**From:** Scala, Mary Joy  
**Sent:** Tuesday, July 26, 2016 3:58 PM  
**To:** 'vwilson@loughridgeconstruction.com'  
**Cc:** 'stetterton@pricestudios.com'  
**Subject:** RE: BAR Action- 1000 W Main Street - Hardywood Cafe

**RE: Certificate of Appropriateness Application**

BAR 16-07-06

1000 West Main Street

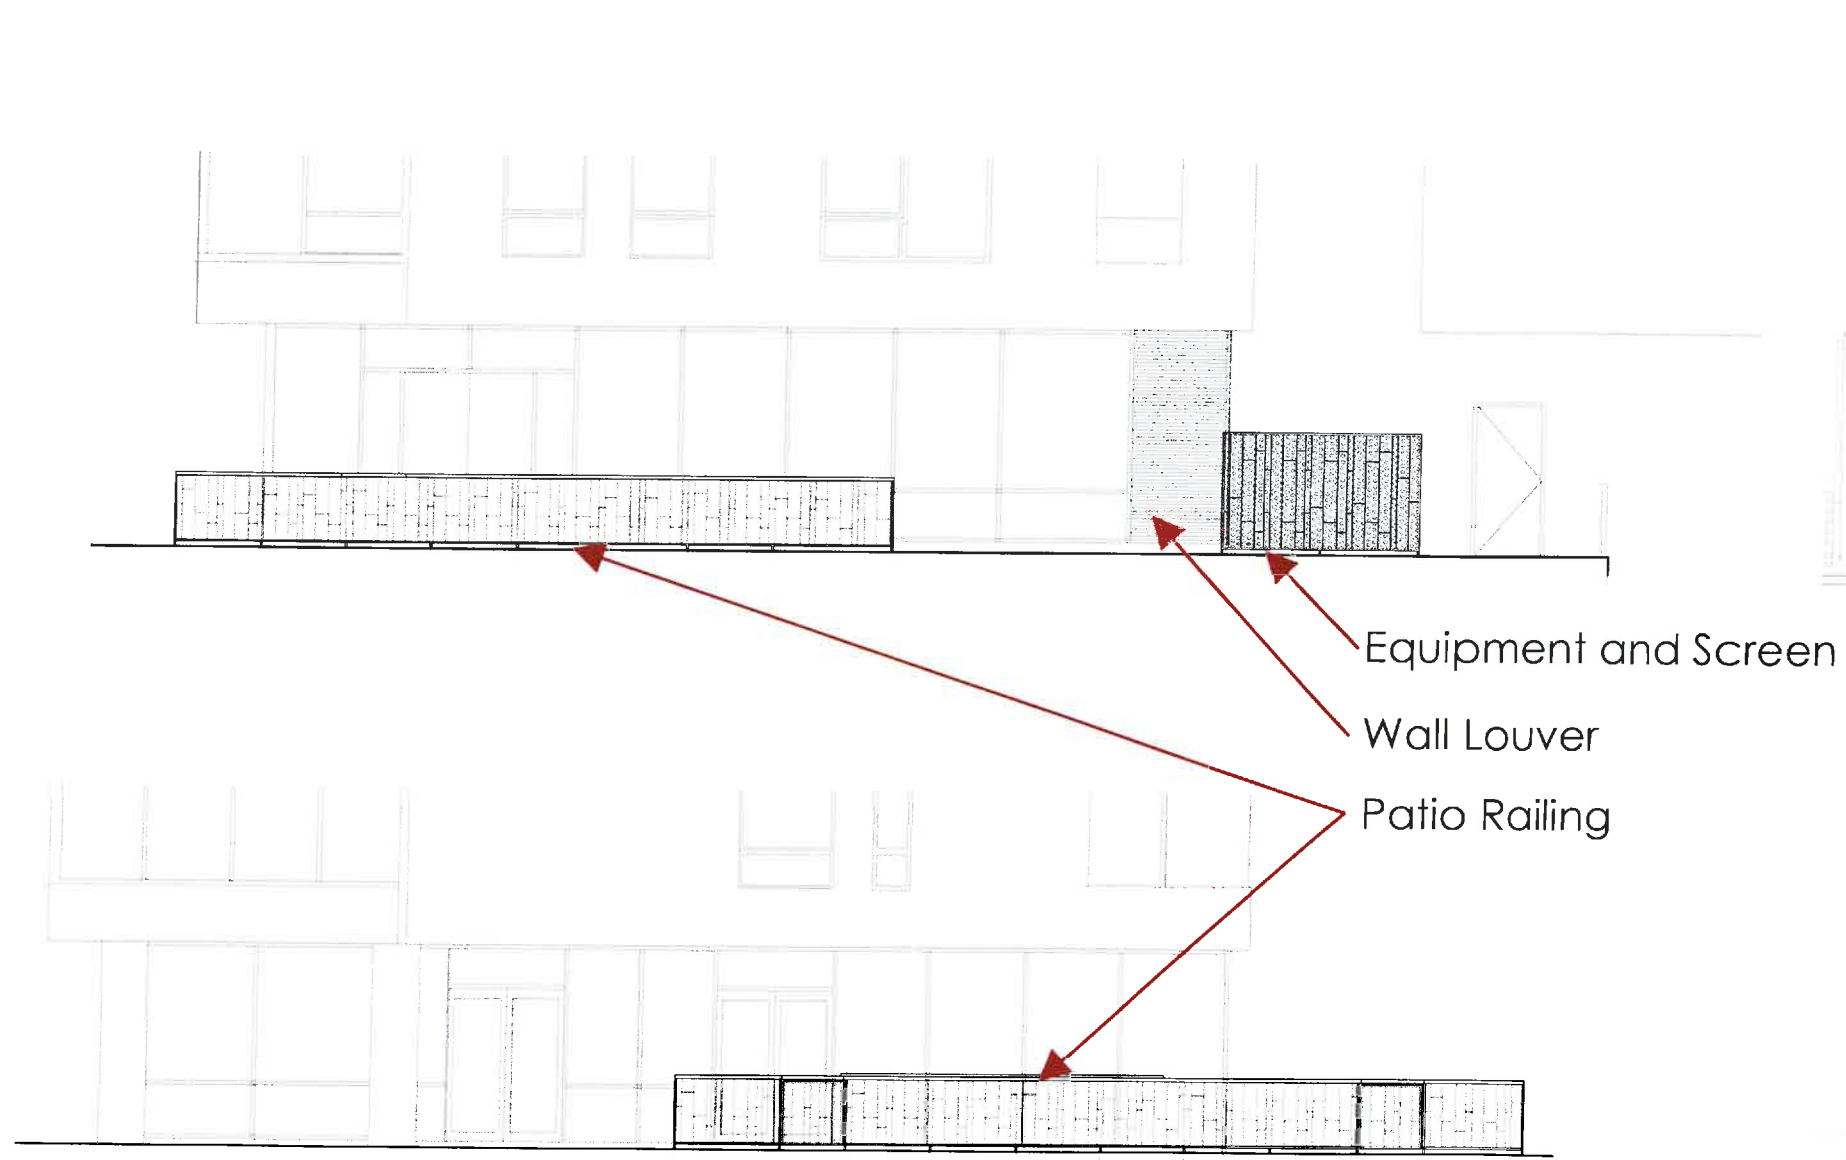
The screen around the mechanical equipment should be explained a little better.

**Mohr moved to find that the proposed additions satisfy the BAR's criteria, and are compatible with this property and other properties in the West Main Street ADC District, and the BAR approves this application, *pending administrative review of the existing railing designs*, with finished wood table tops [on silver or black café furniture], and approved the color and detail of the chiller cabinet [and wall louvers] as submitted. Earnst seconded. Motion passed (7-0).**

**Following administrative review of the railings, the BAR decided that the café railing should match the silver-colored horizontal railings that are installed on the rest of the building.**
